H. B. ROBINSON STEAM ELECTRIC PLANT, UNIT NO. 2

AMENDMENT TO FACILITY OPERATING LICENSE

Amendment No. 82
License No. DPR-23

ATTACHMENT TO LICENSE AMENDMENT

FIGURE 3.1-1

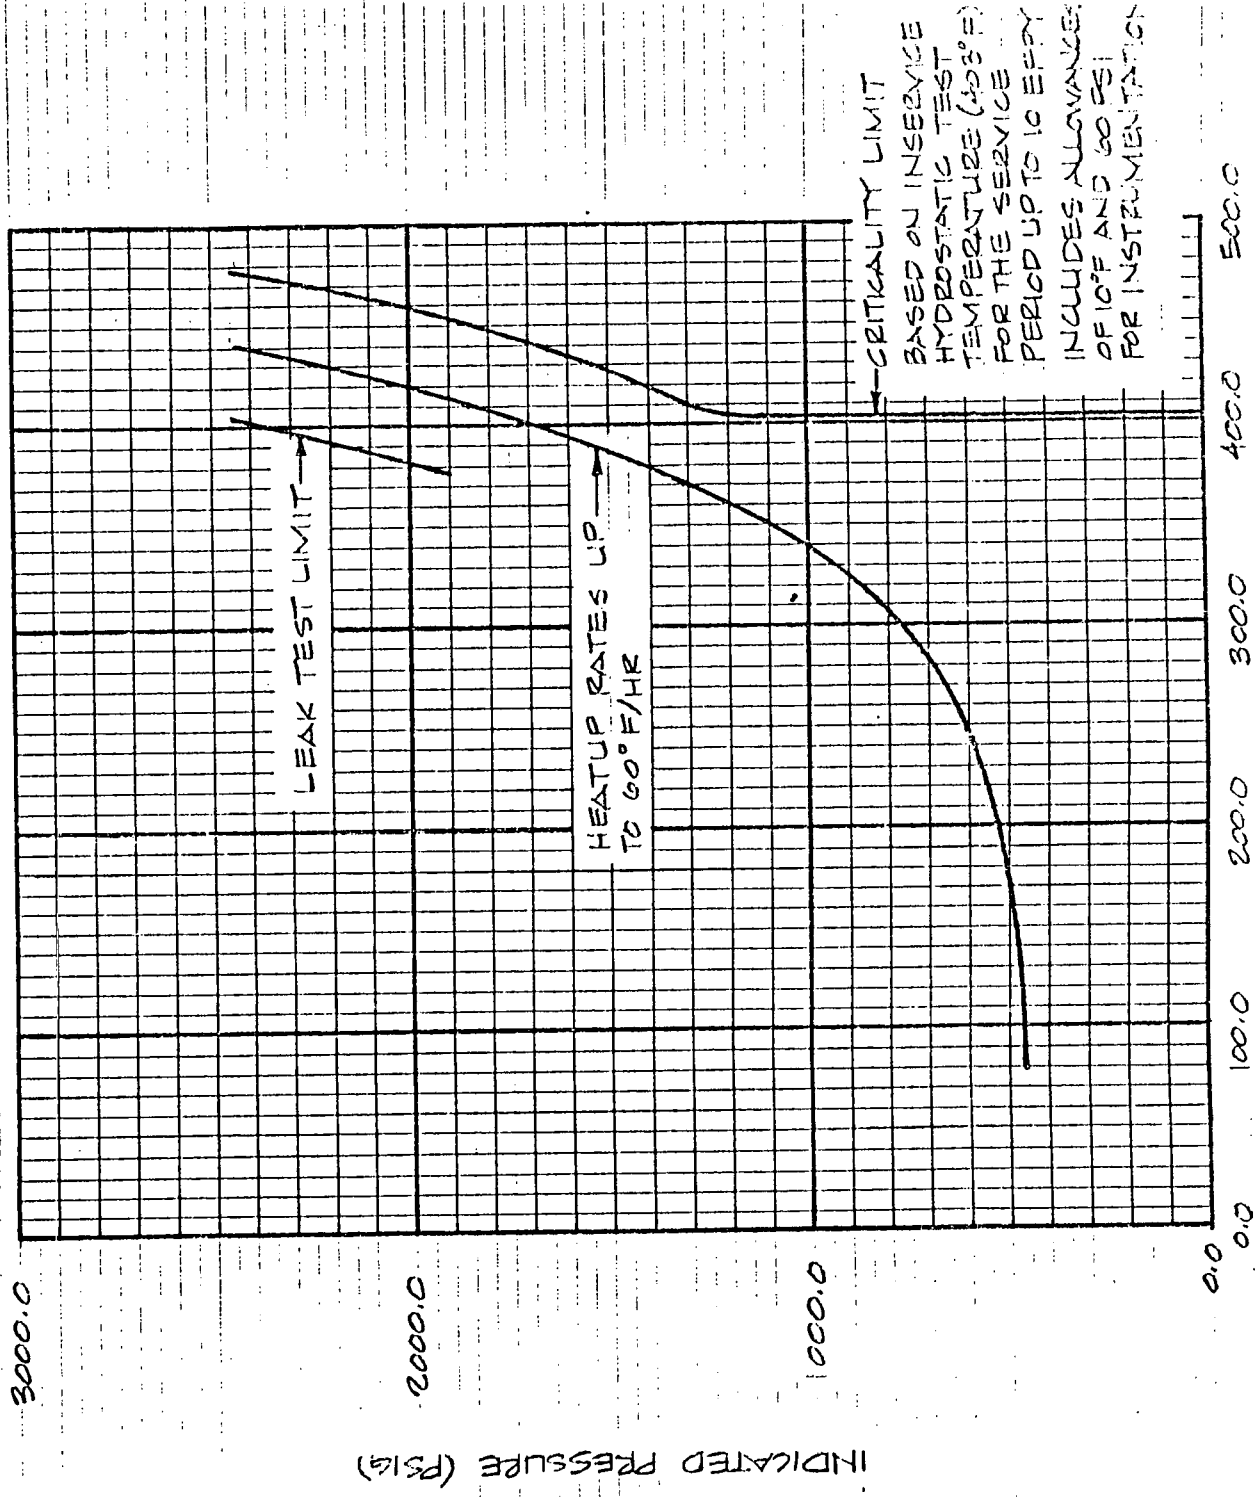
- 3.1.2.4 Figures 3.1-1 and 3.1-2 shall be updated periodically in accordance with the following criteria and procedures before the calculated exposure of the vessel exceeds the exposure for which the figures apply.

- a. At least 60 days before the end of the integrated power period for which Figures 3.1-1 and 3.1-2 apply, the limit lines on the figures shall be updated for a new integrated power period utilizing methods derived from the ASME Boiler and Pressure Vessel Code, Section III, Appendix G and in accordance with applicable appendices of 10 CFR 50. These limit lines shall reflect any changes in predicted vessel neutron fluence over the integrated power period or changes resulting from the irradiation specimen measurement program.

← CRITICALITY LIMIT
 BASED ON INSERVICE
 HYDROSTATIC TEST
 TEMPERATURE (400°F)
 FOR THE SERVICE
 PERIOD UP TO 10 EFPY
 INCLUDES ALLOWANCE
 OF 10°F AND 50 PSI
 FOR INSTRUMENTATION

H.B. ROBINSON UNIT NO. 2 REACTOR COOLANT SYSTEM
 HEATUP LIMITATIONS APPLICABLE UP TO 10 EFPY

FIGURE 3.1-2

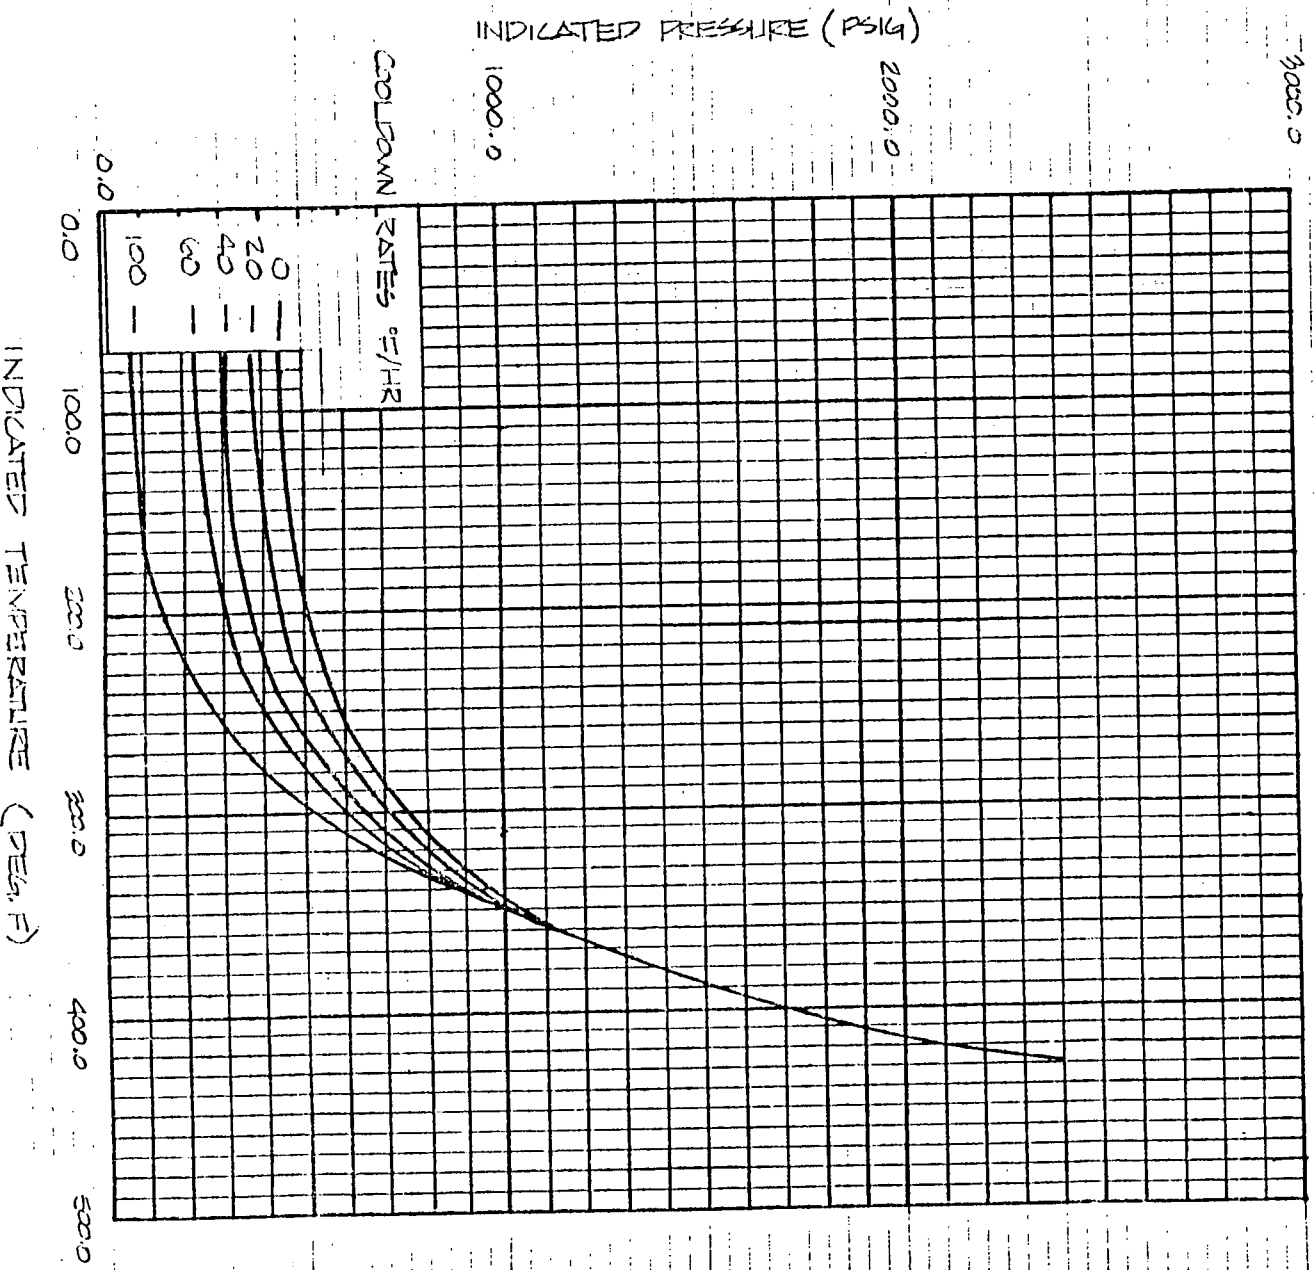
CONTROLLING MATERIAL : WELD METAL
 COPPER CONTENT : 0.95 WT. %
 PHOSPHORUS CONTENT : 0.012 WT. %
 RT NOT INITIAL : 0°F
 RT NOT AFTER 10 EFPY : 1/4T, 274°F
 : 3/4T, 1290°F

CURVES APPLICABLE FOR COOLDOWN RATES UP TO 100°F/HR FOR THE SERVICE PERIOD UP TO 10 EFPY.

INCLUDES 10° AND 60 PSI ALLOWANCE FOR INSTRUMENTATION.

H.E. ROBINSON UNIT NO. 2 REACTOR COOLANT SYSTEM
 COOLDOWN LIMITATIONS APPLICABLE UP TO 10 EFPY.
